**VILLAGE OF DOWNERS GROVE  
REPORT FOR THE VILLAGE COUNCIL MEETING  
SEPTEMBER 2, 2014 AGENDA**

<b>SUBJECT:</b>	<b>TYPE:</b>	<b>SUBMITTED BY:</b>
Acceptance of Public Improvements – Walnut Grove Subdivision	✓ Resolution Ordinance Motion Discussion Only	Nan Newlon, P.E. Director of Public Works

**A RESOLUTION AUTHORIZING ACCEPTANCE OF  
PUBLIC IMPROVEMENTS – WALNUT GROVE SUBDIVISION**

**TO:** Amanda Riordan, Planning & Community Development  
**FROM:** David H. Barber, P.E., Director of Public Works  
**BY:** Michael D. Millette, P.E., Asst. Director of Public Works – Engineering  
 Jonathan C. Hall, P.E., Development Engineer  
**DATE:** May 23, 2005  
**RE:** Planning / Zoning Request  
 Proposed subdivision – Gronych's Walnut Grove south of 66<sup>th</sup> Street between  
 Briargate and St. James Court  
 Public Works Department - 4th Review

Genesis Survey, PC  
EXISTING & PROPOSED UTILITIES

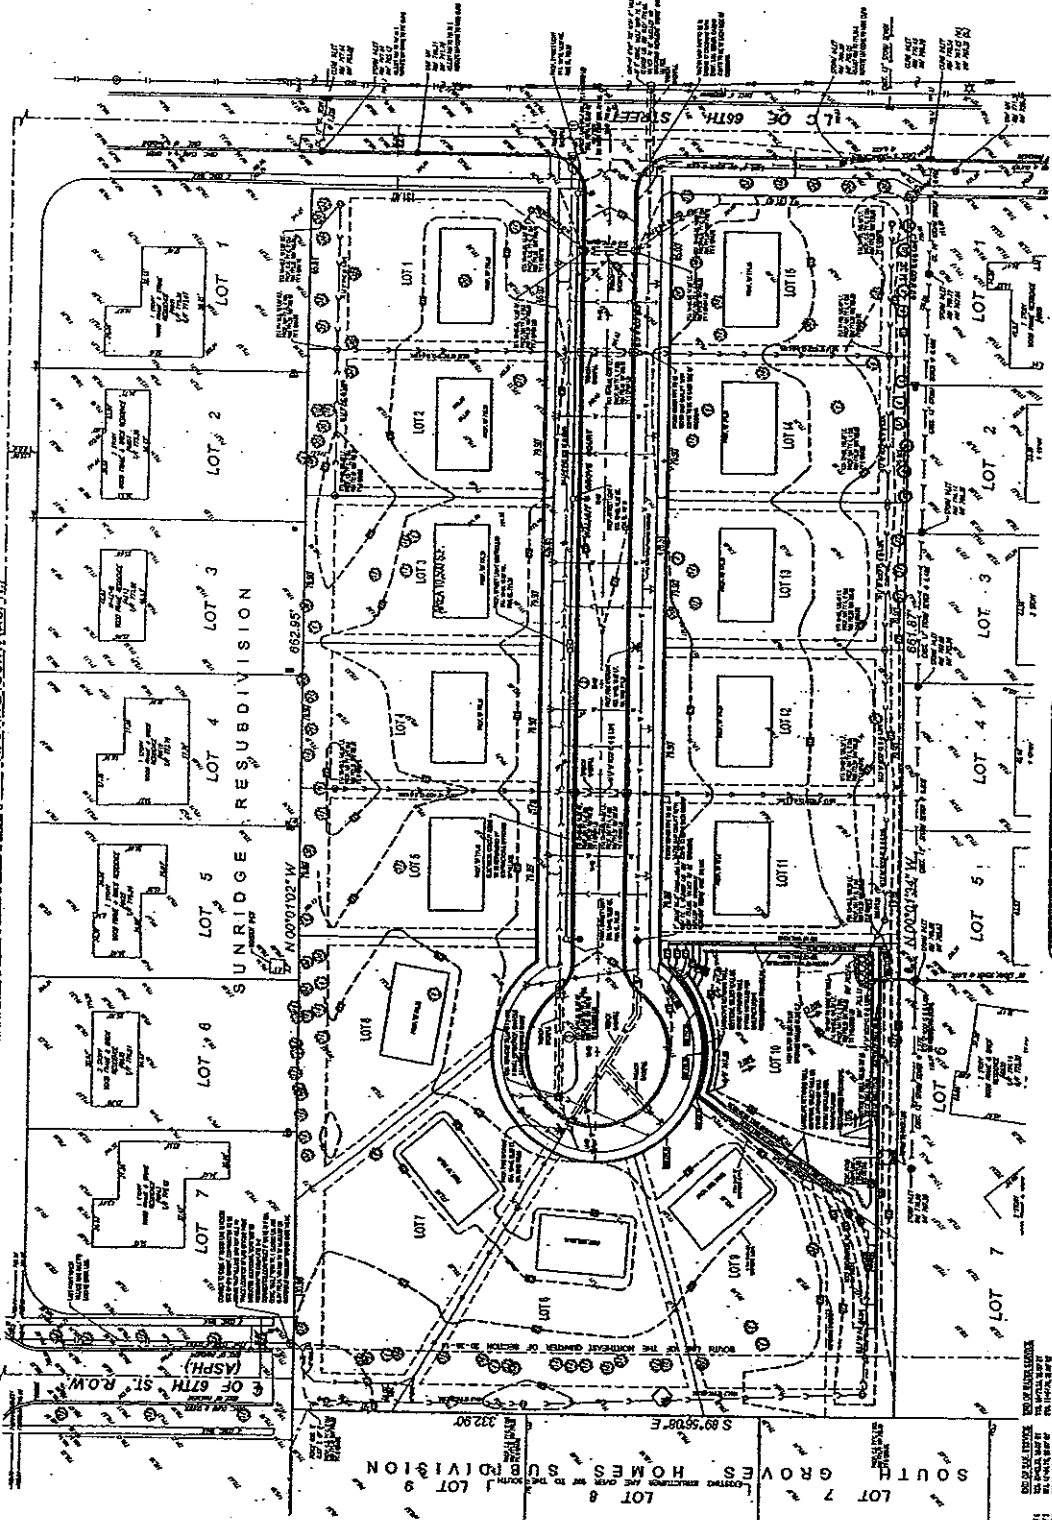
**Accepted**
27. Catch Basin Type A detail refers to PVC storm sewer pipe, which contradicts the RCP notes on the Utility Plan.  
**Accepted**
28. Clearly define and show all overland flow routes, including that from the street to the detention basin. As an alternative, show that inlets and storm sewers can convey the 100-year critical-duration storm with all inlets 50% clogged.

6. Use 45 or 22 1/2 degree fittings at the bends instead of 90-degree bends.
7. The new 8" water main will cross the existing 8" sanitary sewer at 66<sup>th</sup> Street and the water main must be in a casing and be noted on the utility plan.

8. All water services should be noted on the plan as 1 1/2" K Copper.
9. The two proposed fire hydrants must be Waterous WB-67 and meet Village Spec.

EROSION CONTROL PLAN

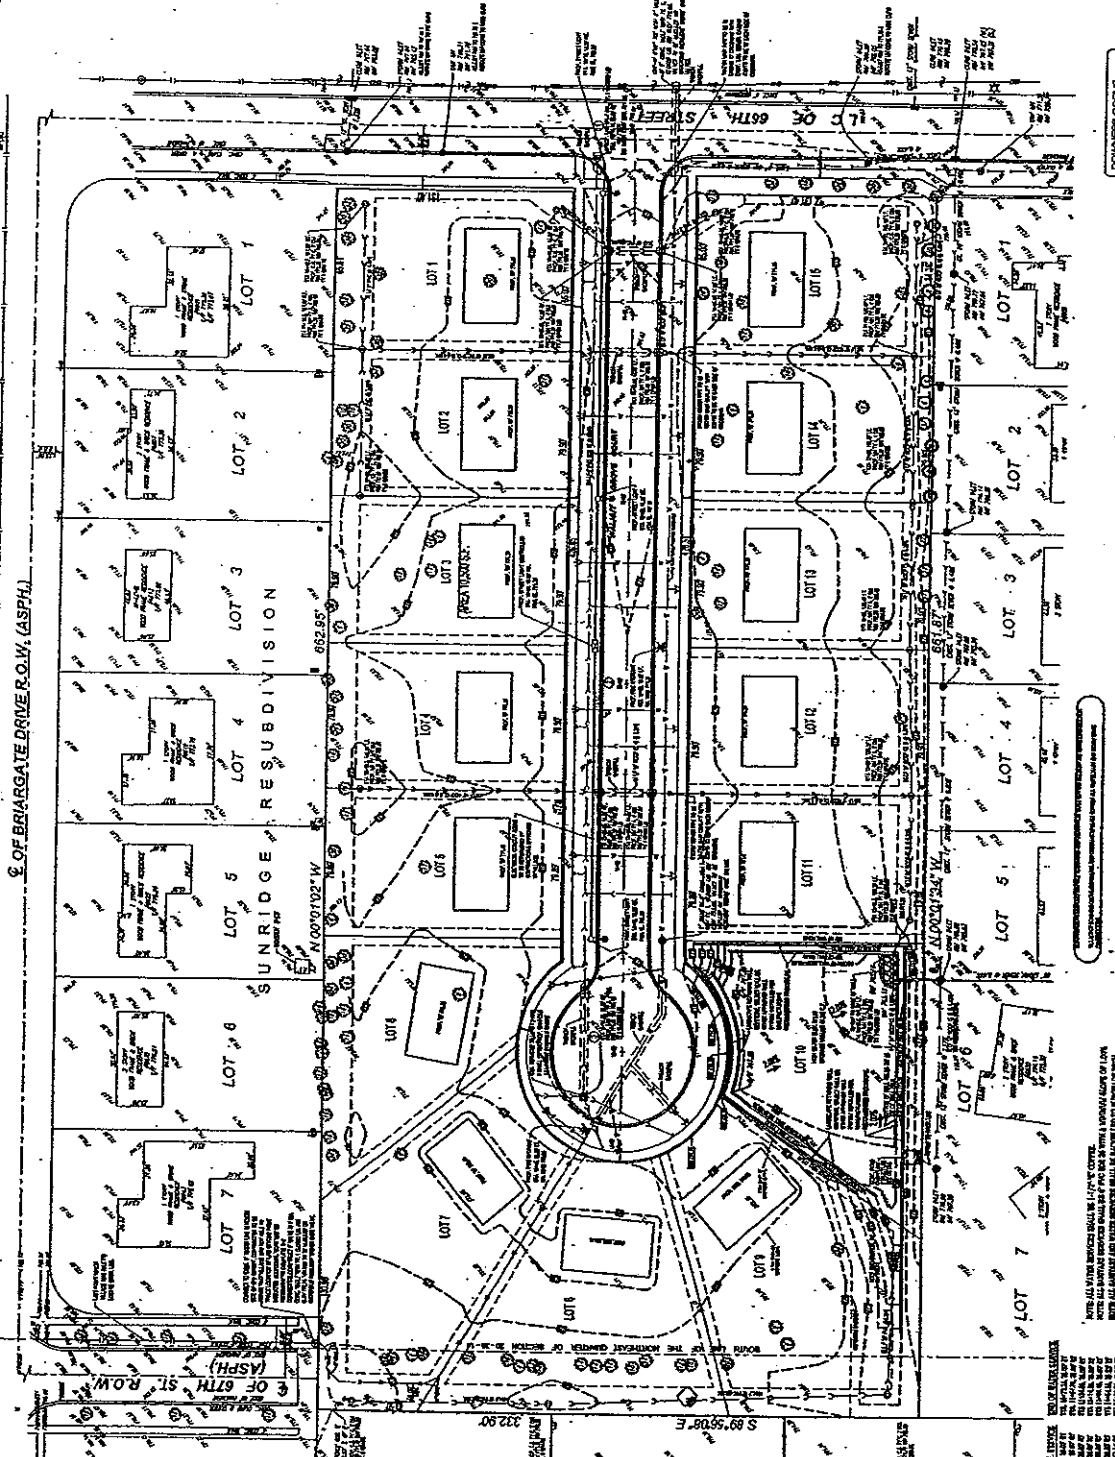
14. Provide structural engineer's sealed design for the detention basin retaining walls.  
**Accepted**
15. Show cross-section of emergency overflow structure (perpendicular to flow).

**Accepted**
21. Clearly identify trees to be saved and removed on the grading plan.  
**Accepted**
22. Relocate storm sewer street inlets adjacent to Lots 1 and 15 further to the north to capture more of the Walnut Grove Court runoff.
